Product Change Notification

Product Change Notification: PCN-26-290294

EP2.5 DTV housing

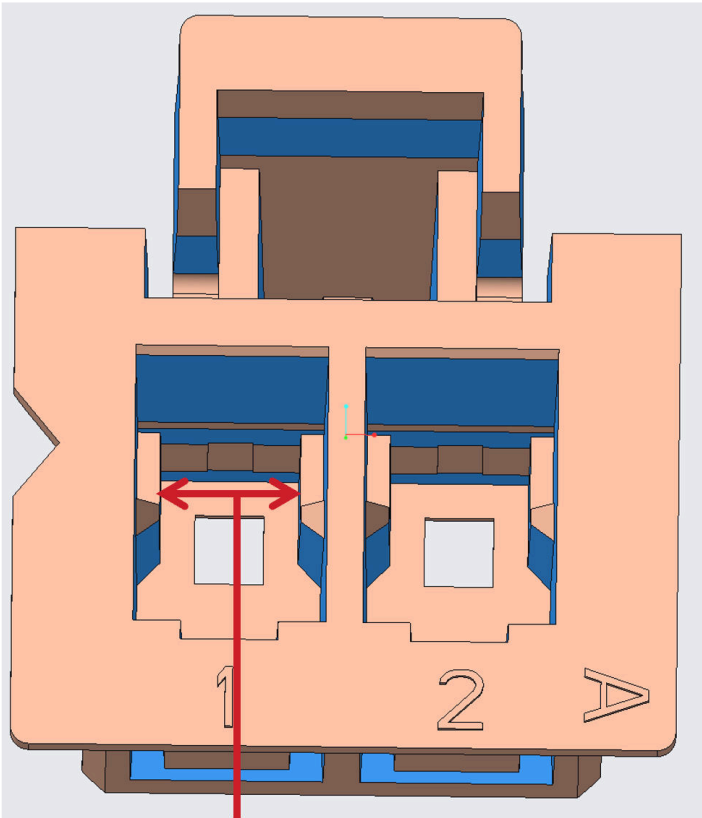
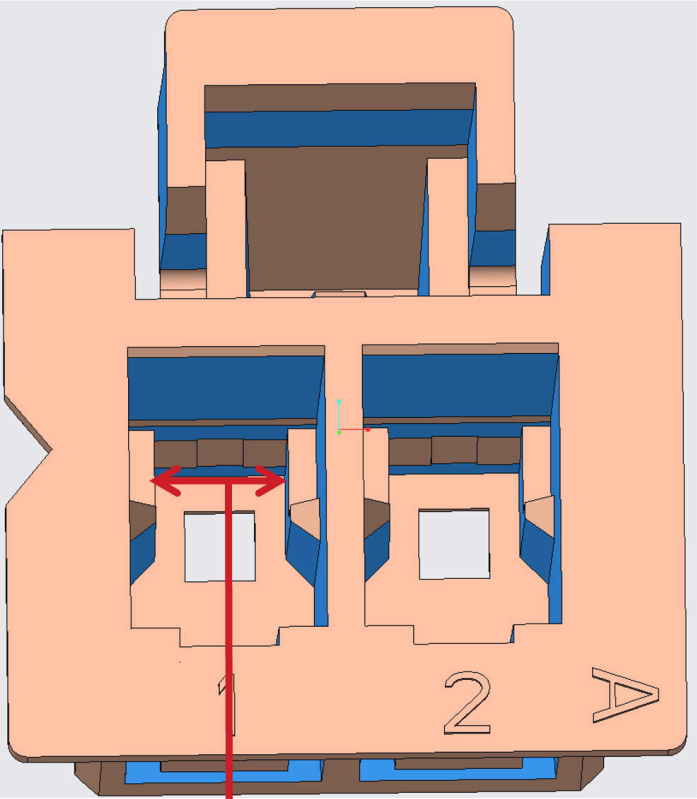
Please be aware of an upcoming feature change to the listed part numbers. Before: the slot width is 1.60mm/1.5mm After: the slot width is 1.40mm Reference performance test data:TP-26-01640

The slot width is 1.60mm/1.5mm.

1.50mm
Initial

The slot width is 1.40mm.

1.40mm
Improved

Update made to improve customer problem: Terminal incorrect insertion into housing

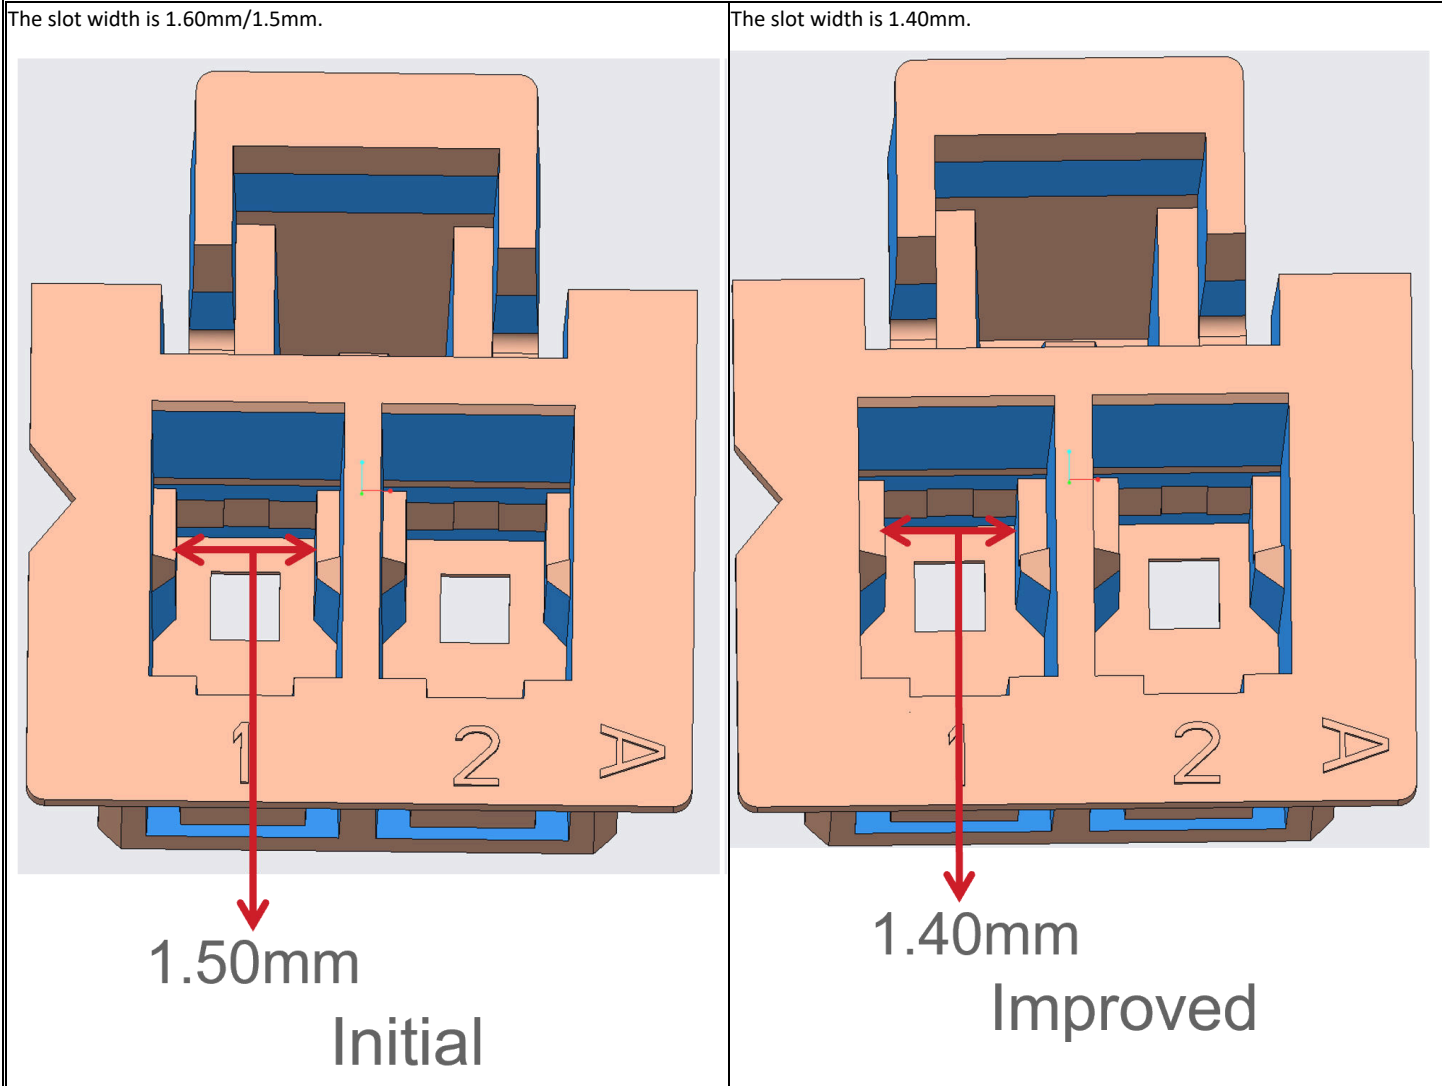
Please be aware of an upcoming feature change to the listed part numbers. Before: the slot width is 1.60mm/1.5mm After: the slot width is 1.40mm Reference performance test data:TP-26-01640

Reason for Changes:
Update made to improve customer problem: Terminal incorrect insertion into housing
